Model: Russian-C4.5	Date: 05-Sep-06	No.: RD007001g
---------------------	-----------------	----------------

Subject: Firmware Release History (Controller)		Prepared by: S. Tomoe	
From: 2nd Tech Support Sec. Service Support Dept.			
Classification:	<input type="checkbox"/> Troubleshooting	<input type="checkbox"/> Part information	<input type="checkbox"/> Action required
	<input type="checkbox"/> Mechanical	<input type="checkbox"/> Electrical	<input type="checkbox"/> Service manual revision
	<input type="checkbox"/> Paper path	<input type="checkbox"/> Transmit/receive	<input type="checkbox"/> Retrofit information
	<input checked="" type="checkbox"/> Other ()

Model: Russian-C4/C4.5		Date: 15-Feb-07	No.: RB205023
Subject: Leaking developer causes PCU gear damage		Prepared by: S. Tomoe	
From: 1st Tech. Support Sec. Service Support Dept.			
Classification:	<input checked="" type="checkbox"/> Troubleshooting <input type="checkbox"/> Mechanical <input type="checkbox"/> Paper path <input type="checkbox"/> Product Safety	<input type="checkbox"/> Part information <input type="checkbox"/> Electrical <input type="checkbox"/> Transmit/receive <input type="checkbox"/> Other ()	<input type="chec

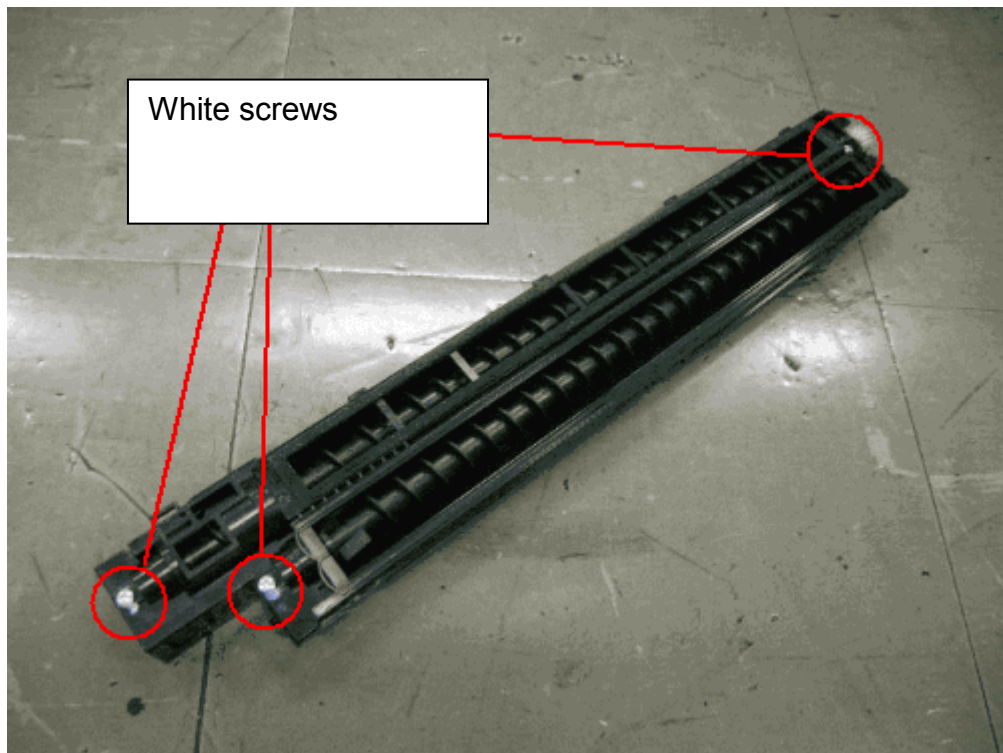
1. The abrasion between the mixing auger and its rear bushing wears down the bushing.
2. Parts that are not listed in the Parts Catalog were replaced in the field.

The strength of the rear bushing was improved so that it can handle the abrasion with the mixing auger.

From February 2007 production of R-C4/C4.5 mainframes, the screws of the PCU are painted white (see the next page). Therefore, when you replace the PCU in the field, **do not loosen or remove these screws.**

How to distinguish the new parts from the old parts

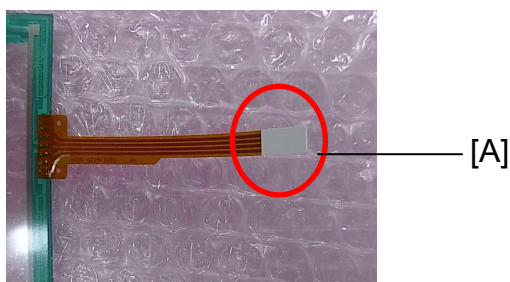
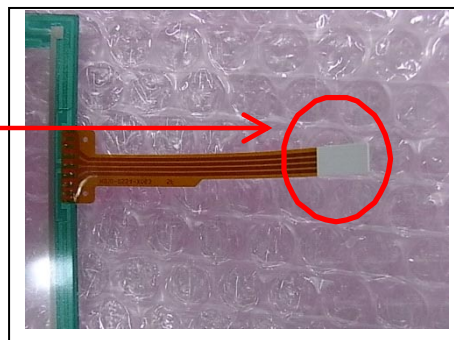
Note: Visual difference between the old and new touch panels:

Old (B2135222): The tip [A] of the electrode attached to the touch panel is **brown**.

New (H3106173): This tip [A] is **white**.

Old parts:
The tip of the electrode is **brown**.

New parts:
The tip of the electrode is **white**.

IMPORTANT: Therefore, if the tip [A] is white, do not replace the touch panel.

6.OPTICS SECTION 2 (B205/B209/D007/D008)

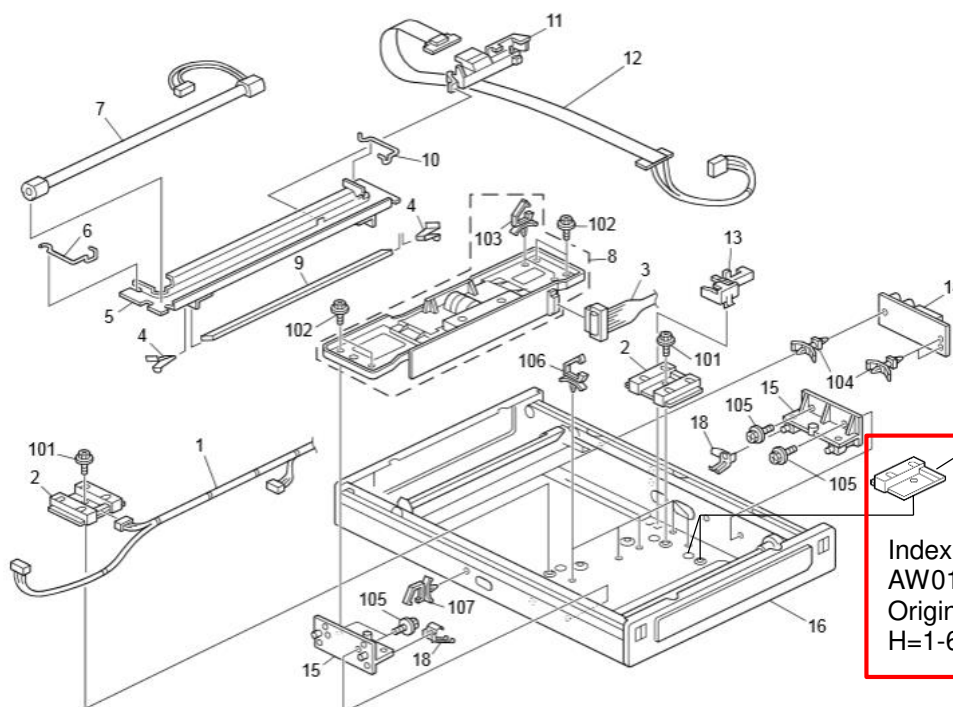
Change: Illustration of the following part was added to the parts catalog. (The part number was described but the illustration had been missing.)

Part number	Description	Q'ty	Page	Index	Note
AW010125	Original Sensor:H=1-66	1	19	17
